Subject: License Renewal Application Clarifications
TAC No. MB8402
Arkansas Nuclear One – Unit 2
Docket No. 50-368
License No. NPF-6

LRA Clarifications

SBO Offsite Power Recovery Diagram

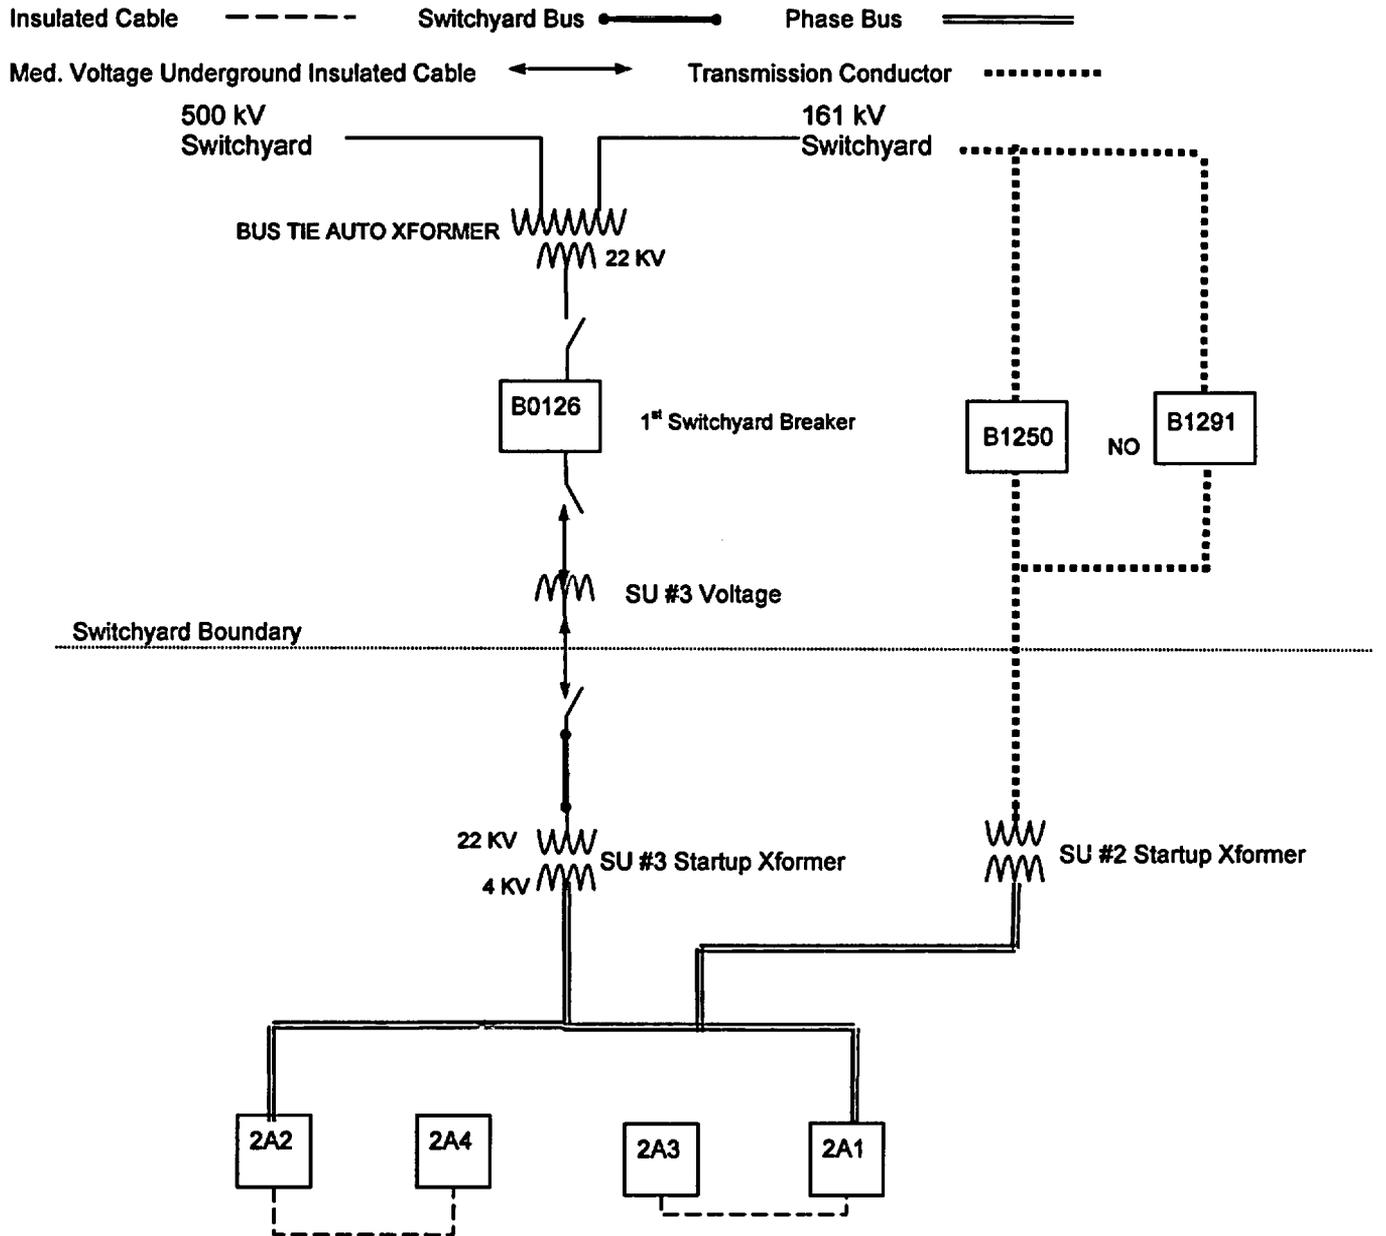
RAI 2.5-2 Clarification: The Staff requested Entergy to include a second offsite power source for SBO recovery as discussed in ISG-2.

Additional Response: Entergy included in the scope of license renewal only the ANO-2 offsite power components required for SBO recovery, which included the connections from Startup 3 to Switchyard Breaker B0126. During a meeting with the Staff on July 20, 2004, the Staff requested that Entergy include a second offsite power source in the scope of license renewal. The second offsite power source is an ANO-1 component credited for General Design Criterion (GDC) 17. Entergy agreed to consider the second source, Startup Transformer #2, in the scope of license renewal and subject to aging management review.

With inclusion of the alternate path for SBO recovery, a description of Startup Transformer #2 and the connection to the 161kV switchyard is provided.

SAR Section 8.2.1.2.G describes the overhead 161kV transmission conductors from 161kV switchyard breakers B1291 and B1250 to Startup Transformer #2. The high-voltage insulators associated with the transmission conductors are similar to the high-voltage insulators for the switchyard bus, which are already addressed in LRA Section 3.6.

The added 161kV switchyard circuit breakers B1291 and B1250, the overhead transmission conductors, and Startup Transformer #2 are shown on the sketch below.
